EVIDENCE FOR

~~SUBMISSION TO~~ THE ROYAL COMMISSION OF INQUIRY:

AN ALTERNATIVE COLLAPSE SCENARIO FOR THE CTV BUILDING

John B. Mander PhD, F.IPENZ

Fig 2.2. Acceleration response spectra comparison at the CTV Building site with the other Geonet recording stations within the Christchurch CBD (when actively recording).

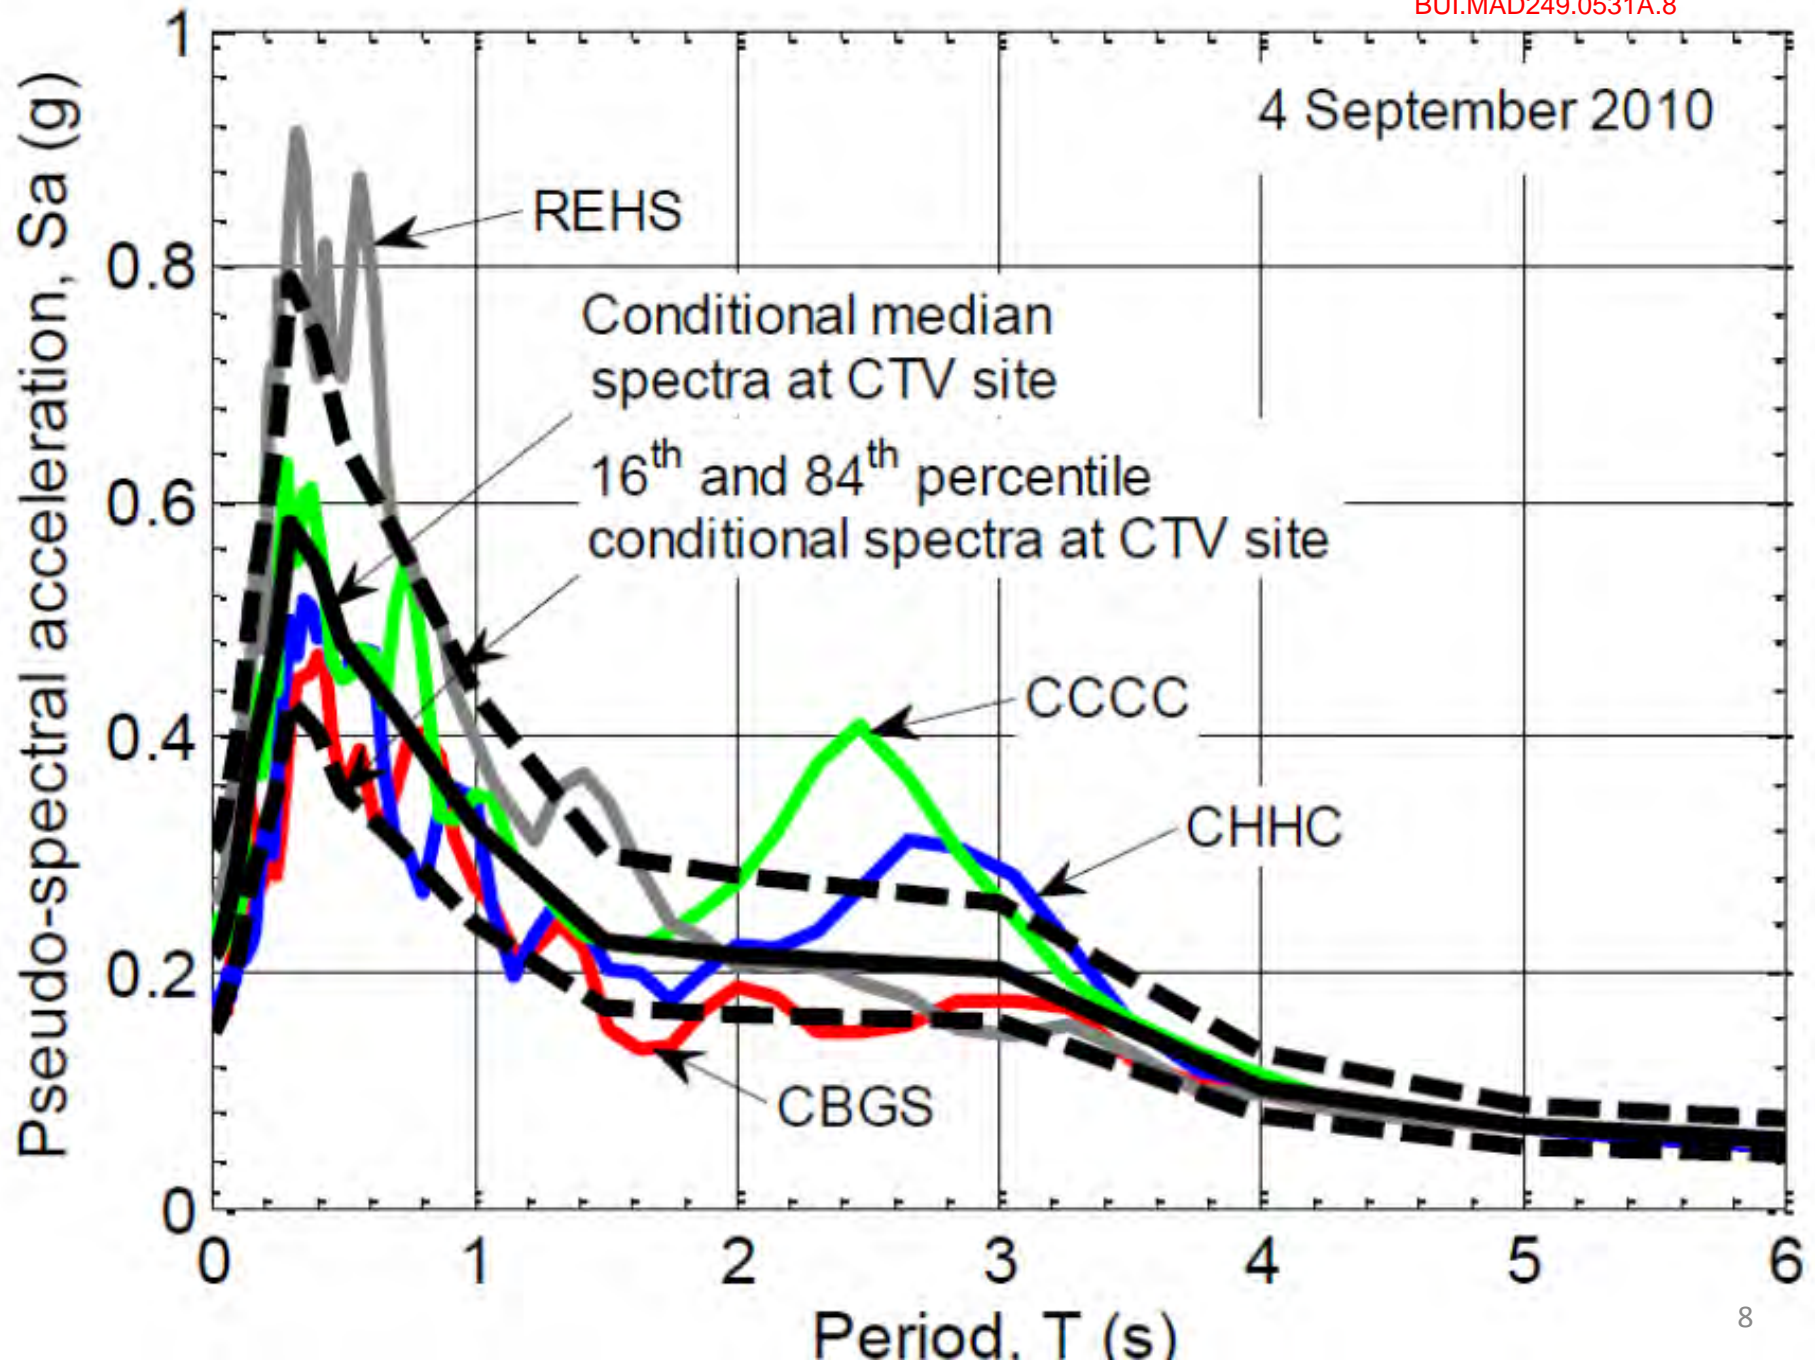
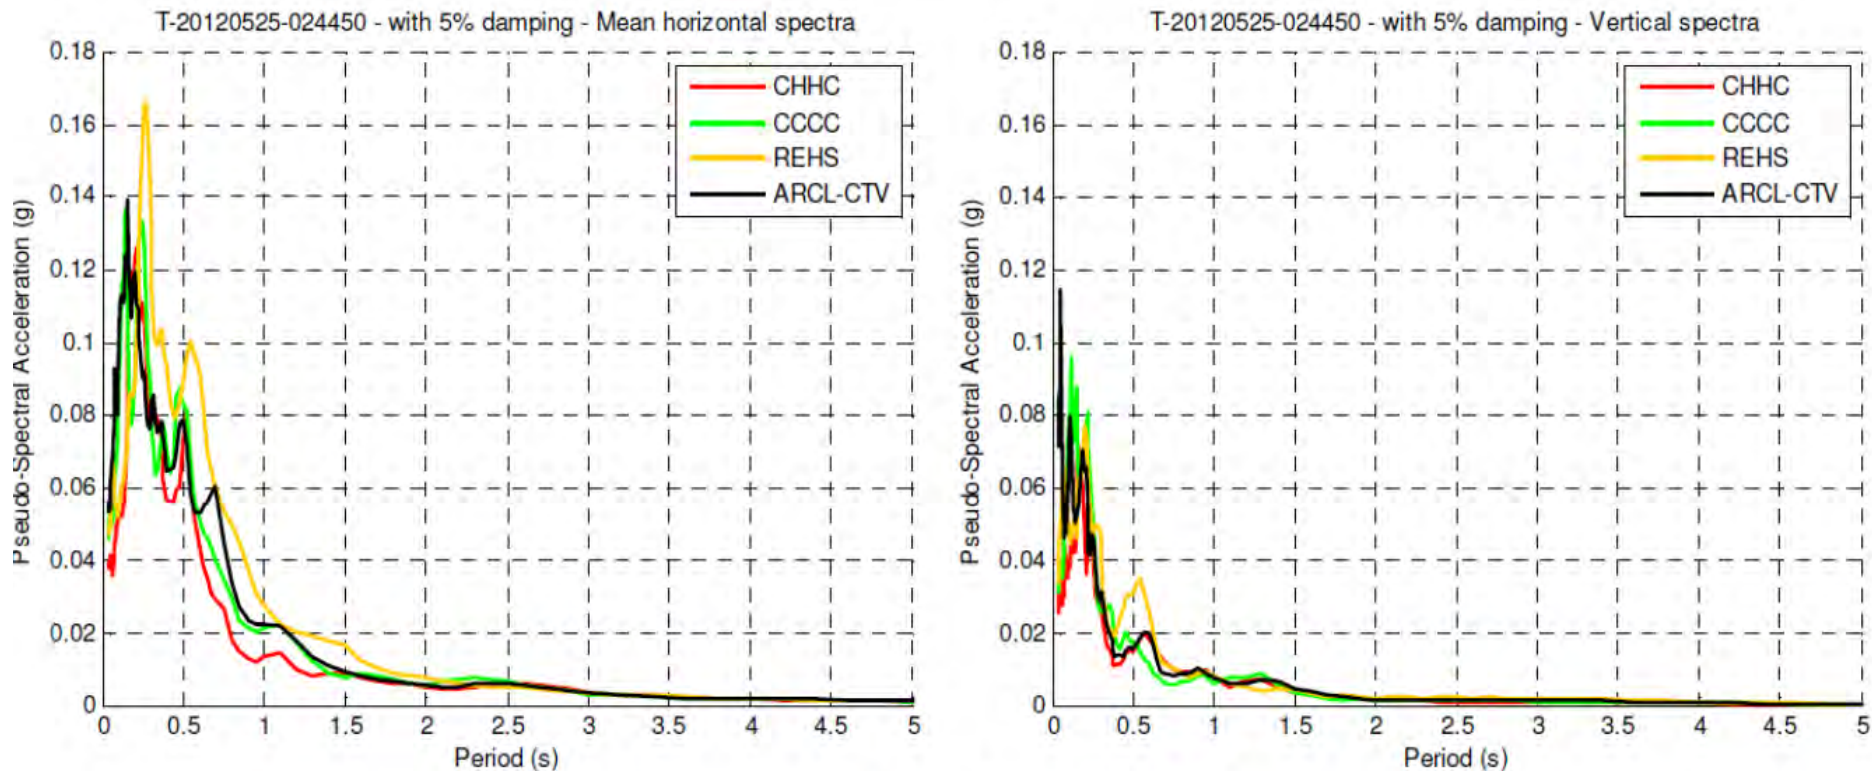
- CCCC at the Christchurch Catholic Cathedral College
 - CBGS at the Botanical Gardens
 - CHHC at Christchurch Hospital
 - REHS at Resthaven Home
-
- REHS: conspicuous by its absence, why?

T-20100903-163541 - with 5% damping - Vertical spectra

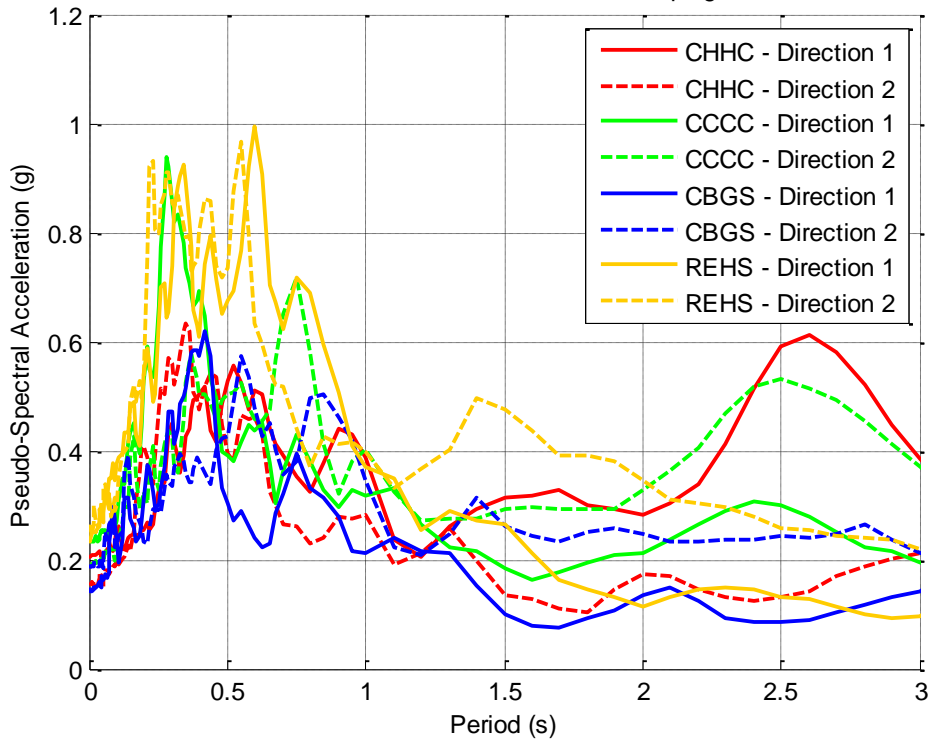
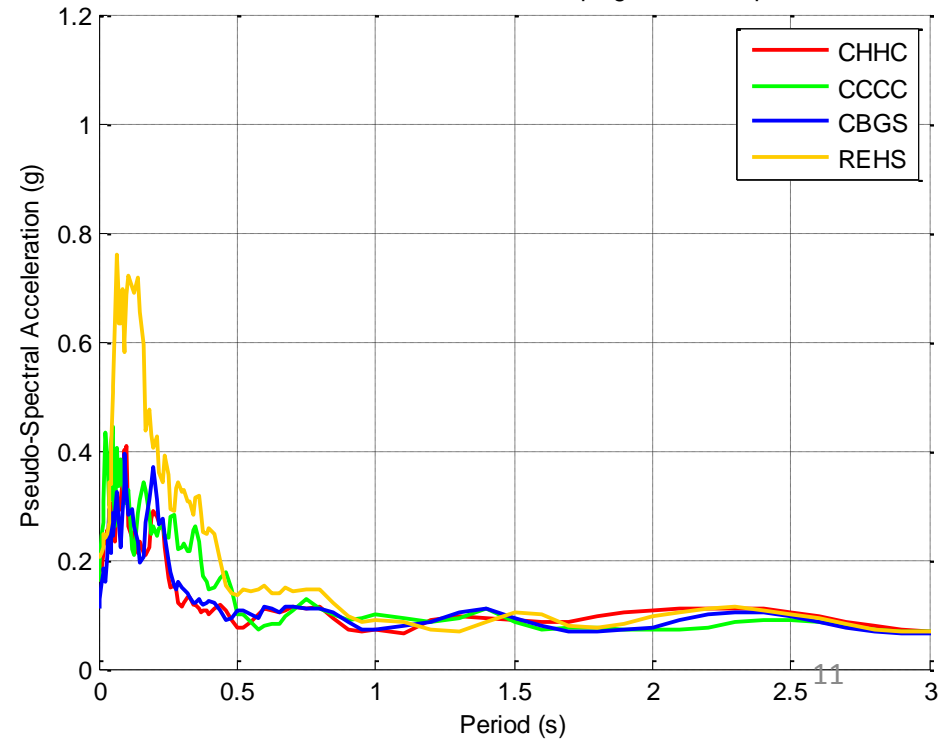
Some have claimed that the Darfield Earthquake vertical motions were not exceptionally high, is this true or false?

Column Concrete Strength from Tests vs Specified 28-day Strength Distribution NZS 3104:1983

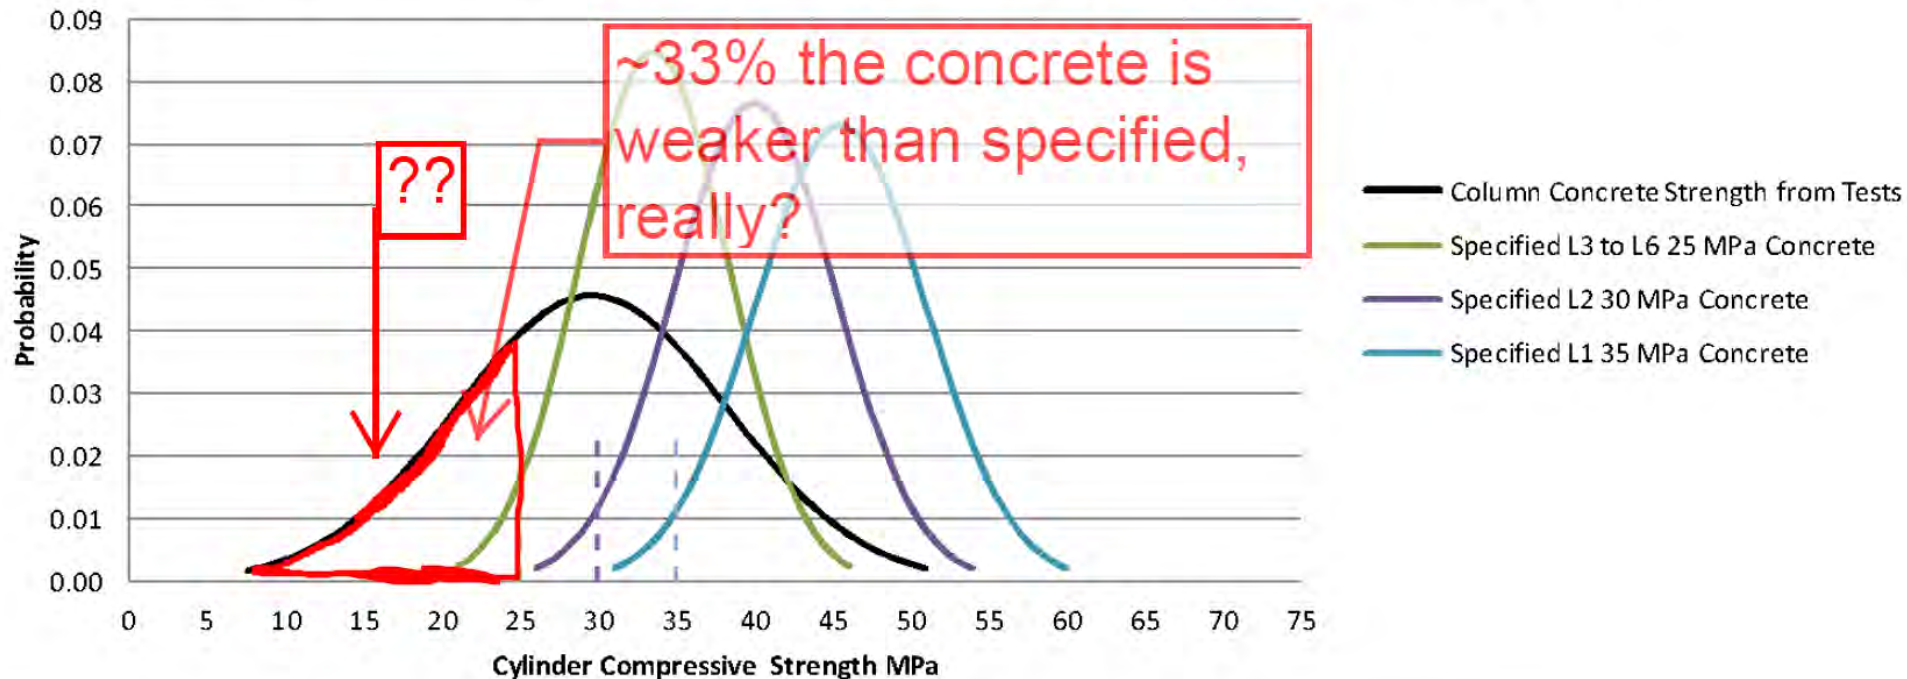
- What is the alarm all about?

Fig. 2.3. Cumulative distribution plot of the normalized concrete strength from the CTL test results.

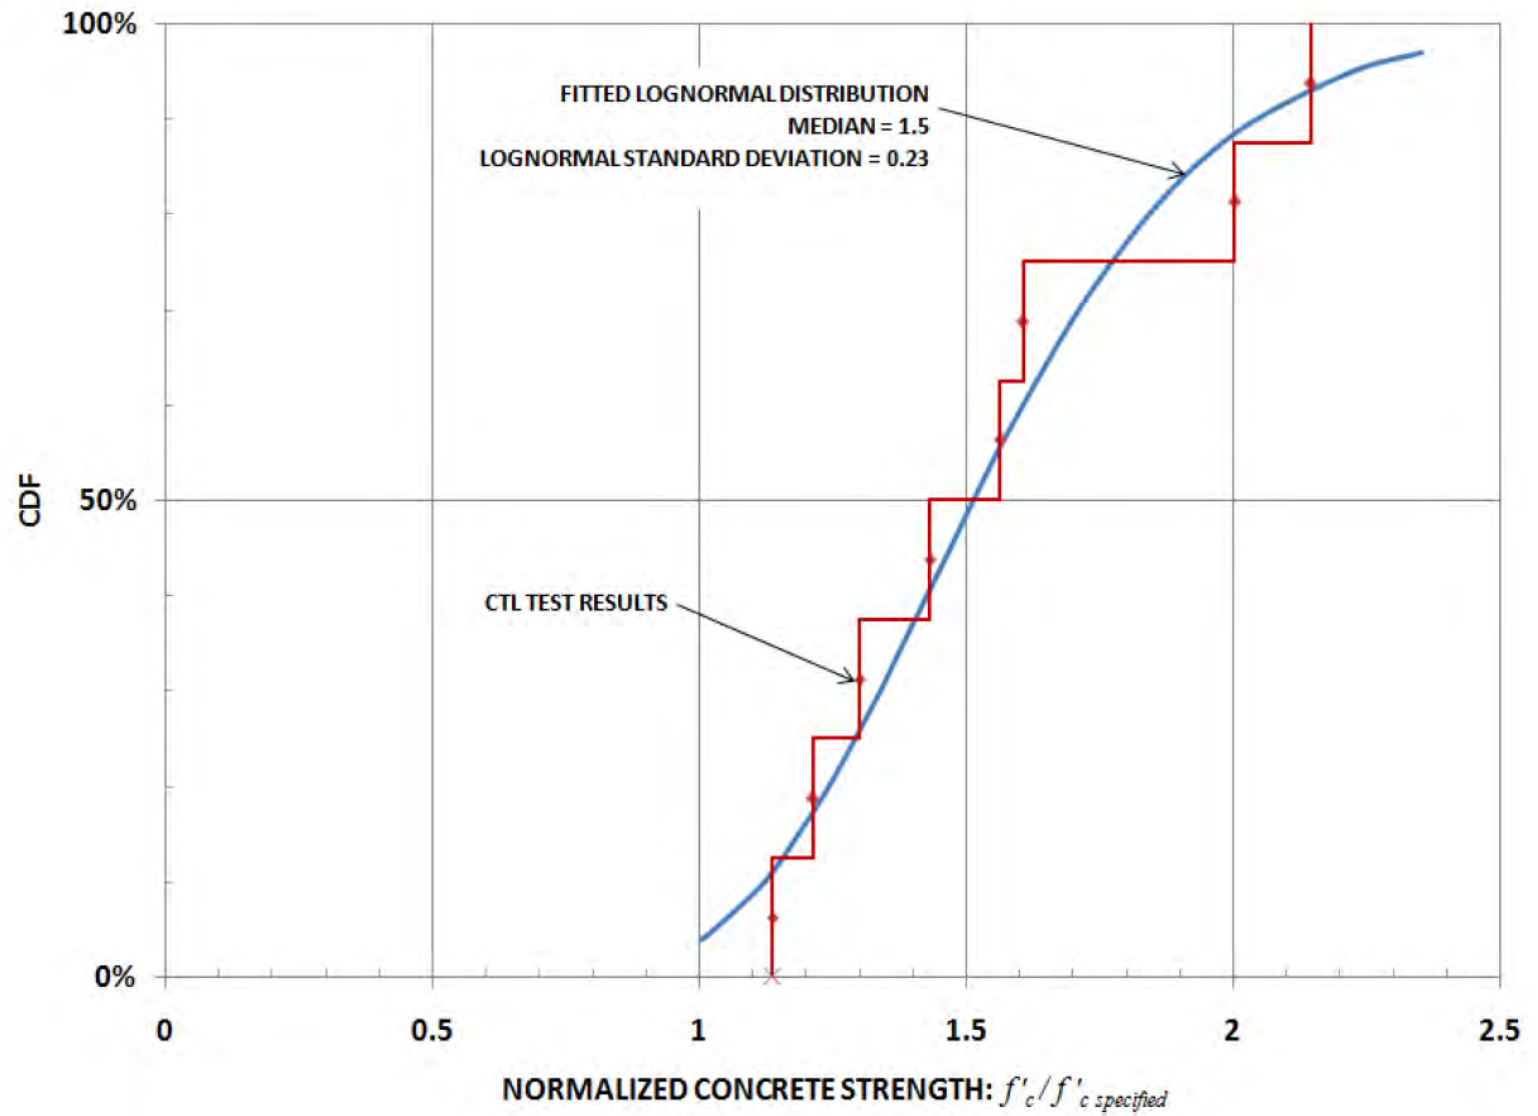
- When conducting an advanced analysis such as NLTHA, it is always prudent to perform a few “swing analyses” to examine the sensitivity of the overall outcomes to values adopted for certain key parameters. In the case of the CTV Building, the concrete strength is a very important parameter, largely because the columns are compression-critical. It is for this reason that the lower values previously used by Compusoft should be retained to model the extreme possibility of weaker concrete.
- The Compusoft analyses used concrete strengths amplified some 10% above the specified strength. With respect to the median concrete strength observed in the CTL tests, the Compusoft assumed concrete strengths fall approximately on the 10th percentile of the distribution (see the blue curve in previous Figure)

Fig. 2.4. The three column portions retrieved from the CTV Building used in the full-scale testing conducted at the University of Canterbury

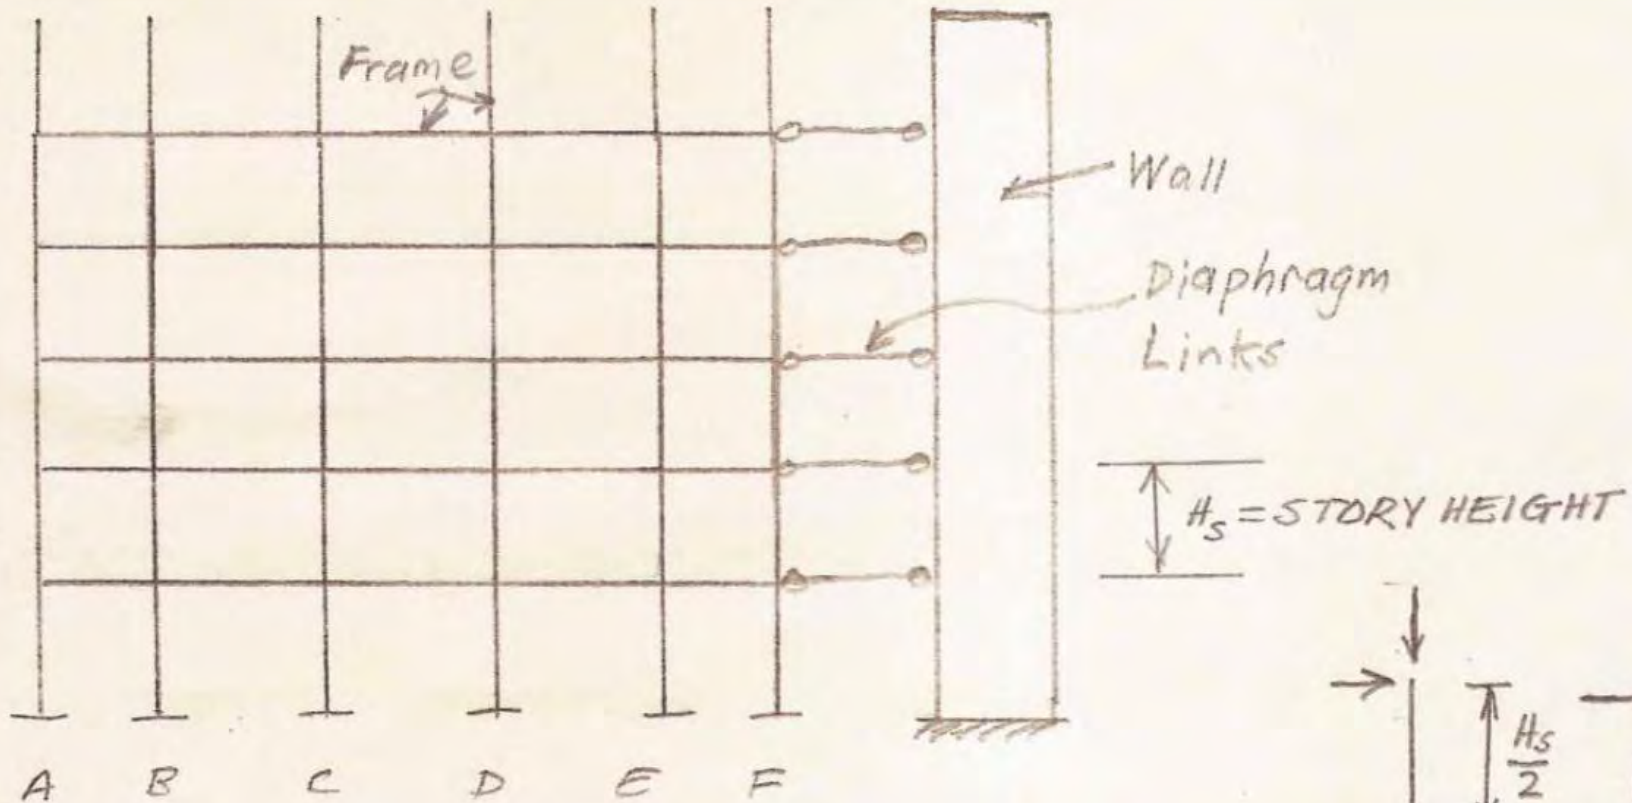
- The concrete strength is above the specified value of

$$f'_c = 25 \text{ MPa.}$$

- There is a size-effect present.
 - This may be in the order of $f'_{co} = 0.85 f'_c$,
